THE TECHNICAL MATERIEL CORP.
MAMARONECK, NEW YORK

Adapter, Counter Shaft

ELEC. DES. APP. | MECH. DES. APP. | PM-584 | A

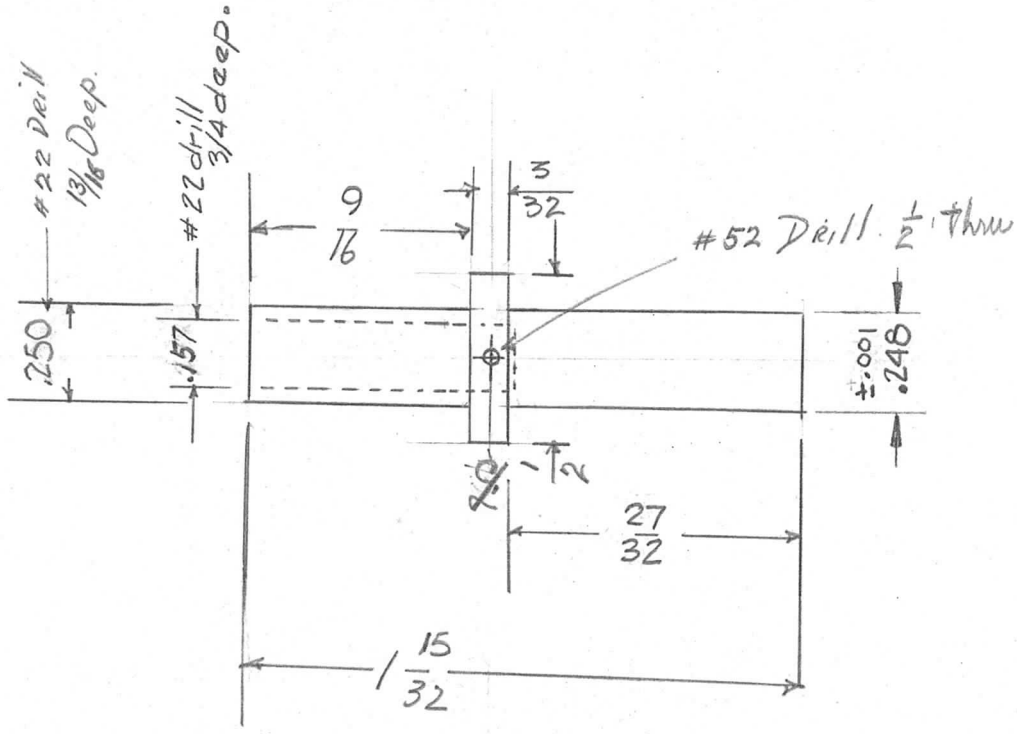
Use PN79-062-6 Pin to Assemble New Shaft.

ISSUE	ITEM	CHANGED FROM	DATE	CH. NO.	DRAFTS	CHECKER	ENG. APP.
A	2	.248 ±.001 Added	11/19/59	1583	DM	[illegible]	[illegible]
	1	1 15/32 was 1 13/32; 27/32 was 3/4 .250 was .248; 11/16 was 13/16
